Docket Number:	18-AAER-08
Project Title:	Federally Exempted Linear Fluorescent Lamps
TN #:	229546
Document Title:	California Investor Owned Utilities Comments on Draft Staff Report
Description:	N/A
Filer:	System
Organization:	California Investor Owned Utilities
Submitter Role:	Public
Submission Date:	8/26/2019 2:46:53 PM
Docketed Date:	8/26/2019

California IOUs Comment on Draft Staff Report

Response to the California Energy
Commission's Draft Staff Report for
**Federally Exempted Linear
Fluorescent Lamps**
18-AAER-08

Figure 1: Average efficacy of linear lamps by length and technology.

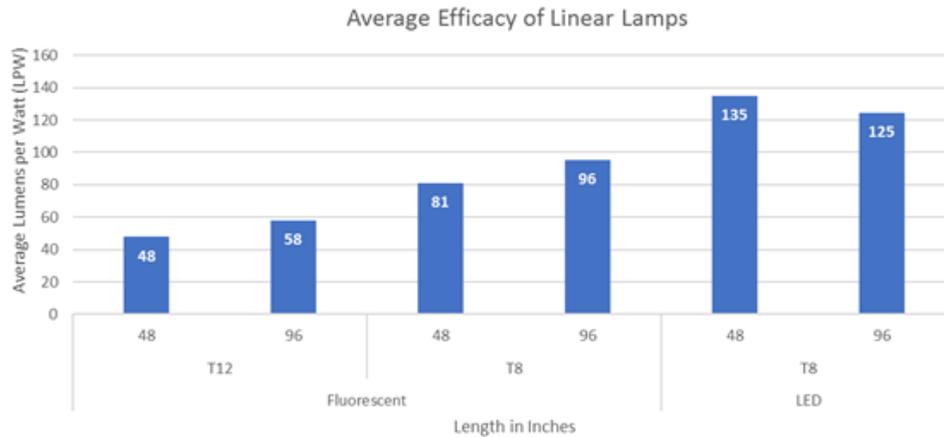
Following the release of the aforementioned CASE Report on May 24, 2018, the Statewide CASE Team gathered additional online retail data for fluorescent lamps to support the recommendation for LED-level performance. Research across 31 brands and approximately 2,600 model numbers revealed that the average efficacy of a 4-foot, high-CRI T12 lamp, is 48 lumens per watt (LPW), at a cost as low as \$1.28 per lamp (in a 30-lamp case). Herein lies a loophole: consumers buy inefficient T12 fluorescent lamps not for the necessity of high CRI or impact resistance but for the low initial cost. The purchase of the inefficient product occurs instead of the higher cost, higher efficiency T8 or TLED lamps. Similarly, 8-foot, high-CRI T12 lamps have an average efficacy of 58 LPW at a cost as low as \$2.92 per lamp. Efficacy comparisons are shown in Figure 1.

UL Type A and Type B TLEDs, which make up nearly 85 percent of LED non-integrated replacements, are cost-effective and widely available; 4-foot UL Type B TLED lamps are available as low as \$4.74 per lamp (in a 12-lamp case) and have a median efficacy of 125 LPW. The calculated benefit-to-cost ratio for 4-foot TLED lamps is 4.8, for 8-foot TLEDs it is 5.3 (Statewide CASE Team, 2018). Many TLEDs are available with plastic enclosures, making them impact resistant.

For 4-foot standard and high output lamps, as well as 8-foot standard output sized lamps, the Statewide CASE Team recommends that the Energy Commission require an efficacy of 110 LPW in high-CRI and impact-resistant applications of these lamp sizes. Aligning with the Statewide CASE Team proposal would increase the energy savings by 100.2 GWh to a total of 2,995.2 GWh savings, after stock turnover (California Energy Commission, 2019a). The Statewide CASE Team requests that the Energy Commission consider updating the stringency for these lamp types: 4-foot standard output (miniature and medium bipin), 4-foot miniature bipin high output, and 8-foot slimline.
